**0 General****0.1 Manual amendments**

No.	Page	Description	Date
1	0.5, 0.6, 4.14-4.16 diagrams 7, 11, 12	Manual revision TN 413/2	September 2003
2	0.6, diagrams 1 and 11	Manual revision TN 413/3	May 2004
3	0.4, 0.6, 1.9, diagram 7	Landing gear / over centre lock in extended position TN 413/7	Nov. 2004
4	0.4, 0.5, 0.11, 2.6, 6.2, 6.4, 7.1	Manual revision TN 413/8	January 2005
5	0.4 - 0.6, 0.10, 1.9, 1.10, 4.7 - 4.9 Diagramme 17, 18	landing gear positive locking device TN1000/13	February 2008
6	0.4, 0.6, 0.10, 1.14 diagram 6a	ÄM 1000-02 Fin ballast tank valve and handle	March 2008

Landing gear positive locking device

diagram 17  
issued February 2008  
TN1000/13

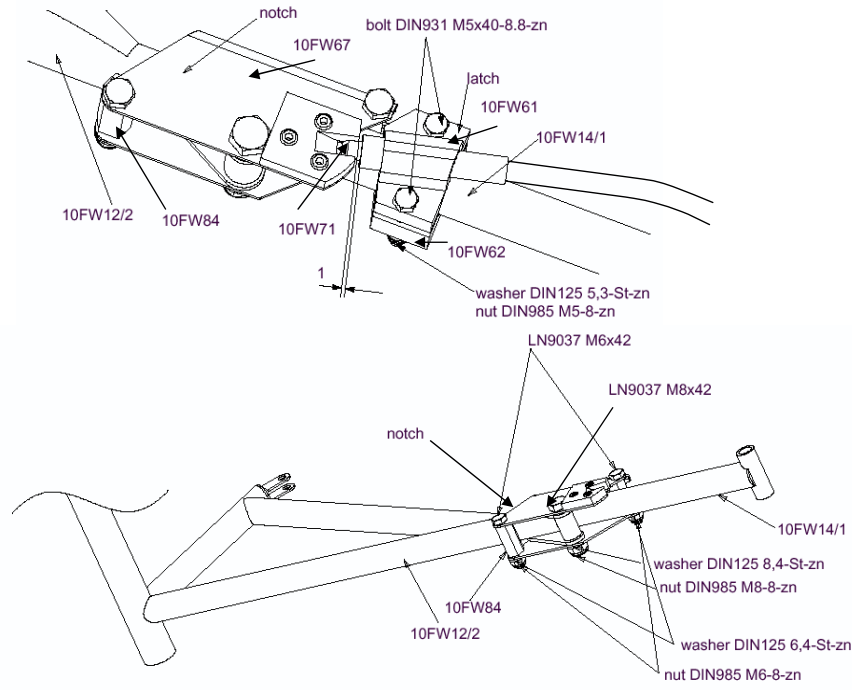
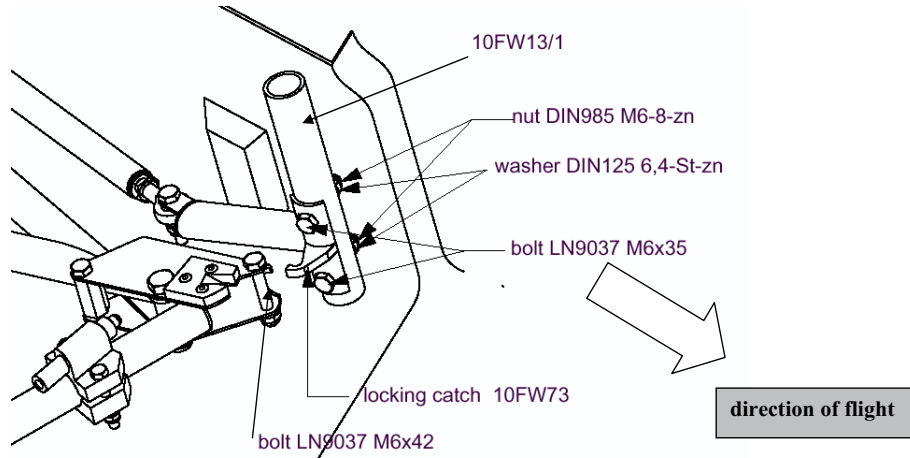
#### **With TN1000/13 executed, standard from ser. no. 10-133 on:**

An additional landing gear positive locking device (notch and latch at the landing gear struts) secures the landing gear in the extended position.

An additional catch in the front upper area of the landing gear box secures the landing gear in retracted position. See diagrams 17 and 18.

Adjust the cable via the adjustment screw in part 10FW74 so that the locking pin disengages when retracting the landing gear. The distance 1mm according to diagram 17 also applies for the disengaged locking pin.

diagram 18  
issued February 2008  
TN 1000/13

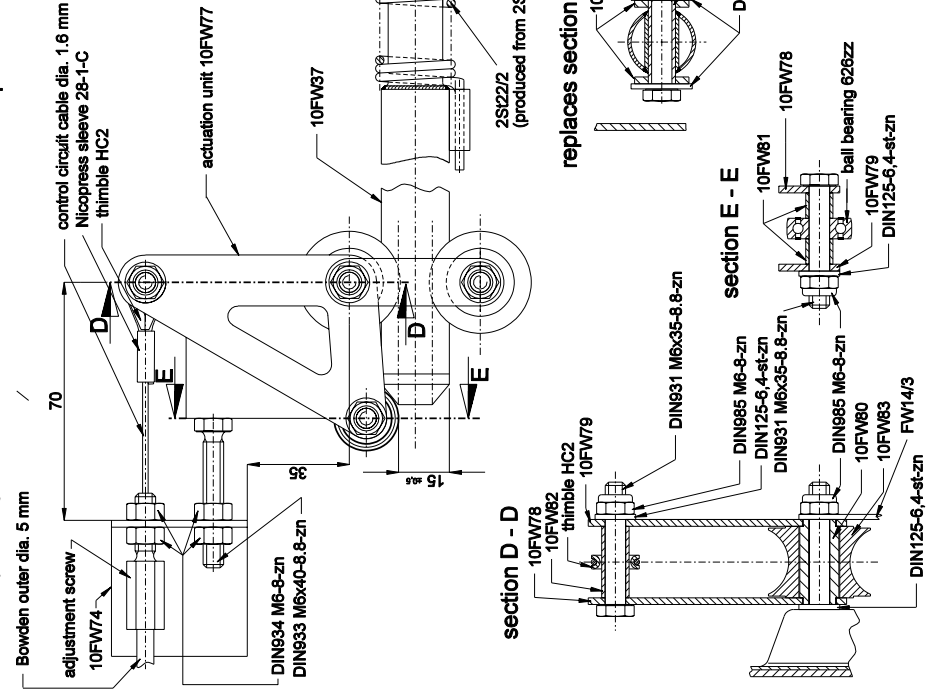
additionally to diagram 12

replaces detail W in diagram 12

replaces section C-C in diagram 12

actuation unit  
LG locking device  
differences to MM diagram 12

Adjust the stop bolt in part 10FW74 so that dimension a will be between 14,5 and 15.5 mm (.57 in. and .61 in.) see diagram 18.
